SOLICITATION AMENDMENT MODIFICATION DE L'INVITATION

Title - Sujet Furniture	
Solicitation No. - N° de l'invitation ET025-201146/A	Amendment No. - N° modif. 004
Client Reference No. - N° de référence du client ET025-201146	Date 2019-10-28
GETS Reference No. - N° de référence de SEAG PW-\$WPG-006-10882	
File No. - N° de dossier WPG-9-42078 (006)	CCC No./N° CCC - FMS No./N° VME
Solicitation Closes - L'invitation prend fin at - à 02:00 PM on - le 2019-11-12	Time Zone Fuseau horaire Central Daylight Saving Time CDT
F.O.B. - F.A.B. Plant-Usine: <input type="checkbox"/> Destination: <input checked="" type="checkbox"/> Other-Autre: <input type="checkbox"/>	
Address Enquiries to: - Adresser toutes questions à: Graham, Danielle	Buyer Id - Id de l'acheteur wpg006
Telephone No. - N° de téléphone (204) 292-2872 ()	FAX No. - N° de FAX (204) 983-7796
Destination - of Goods, Services, and Construction: Destination - des biens, services et construction:

This **amendment # 004** is raised to modify **solicitation # ET025-201146/A** as follows:

RAF.1

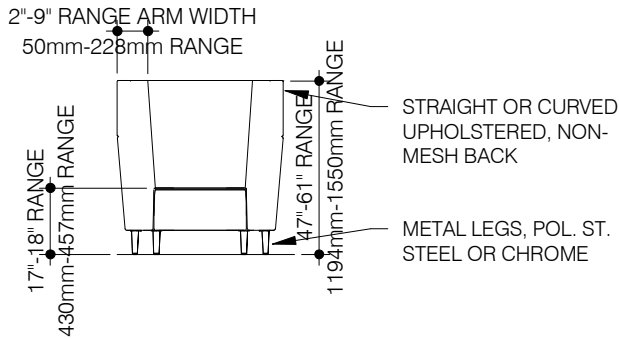
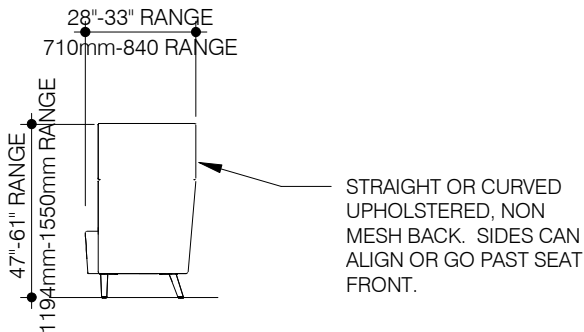
#	NSA Product(s) Description	Qty		Supplier Part Number	Firm Unit Price** \$	Extended Total [Qty x Price] \$
1	LSHB - Refer to drawing RAF.1 for additional information.	16			\$	\$
2	LSB2A double seat bench, 1220mm (48")+- 50mm (2") long x 710mm (28")+- 50mm (2") wide x 457mm (18") seat height. Bench to be upholstered in a low VOC vinyl fabric. Bench to match LSB1, LSB2 & LSB2A.	6			\$	\$
Add more rows if necessary.				Product Total		\$

SEVENTH FLOOR FURNITURE

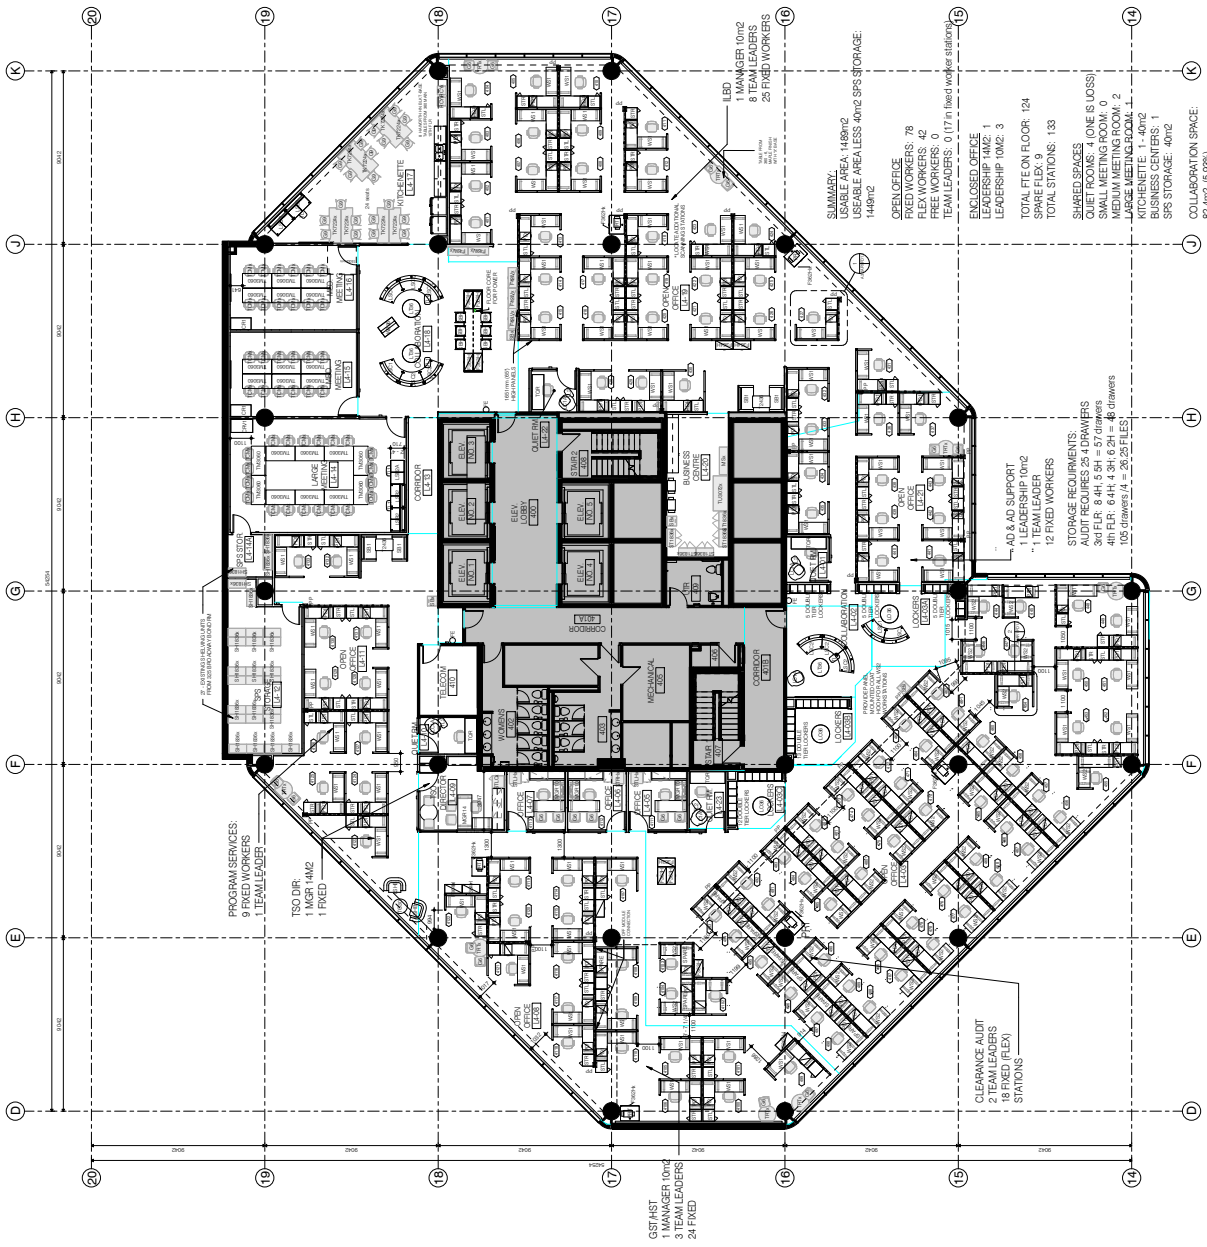
QUESTION: ARE CRYSTALS HOMOGENEOUS?

QUESTION: UPGRADED DESIGN FOR CRYSTALS SUCH AS CRYSTALS FOR ANATASE WITH INTERNAL FACES, IN IT, EDGES, ETC. TO BE INCLUDED IN OFFICE.

QUESTION: LAMINATE SURFACES TO BE HIGH PRESSURE LAMINATE.

ANSWER: CRYSTALS OF ANATASE (PRISMATIC FACES) TEND TO BE FLAT, GRABBER EDGE IN RANDOM FLAT RANGE, WITH INTERNAL GEOMETRIC ORDER, MINIMUM FIVE OR COLOURS IN INTERNAL.

ANSWER: FOR CRYSTALS, WHERE FLAT, OFF WHITE IS INDICATED, USE A HIGH PRESSURE LAMINATE, OR FLAT OFF WHITE COLOUR, FINAL COLOUR, FLAT RANGE.
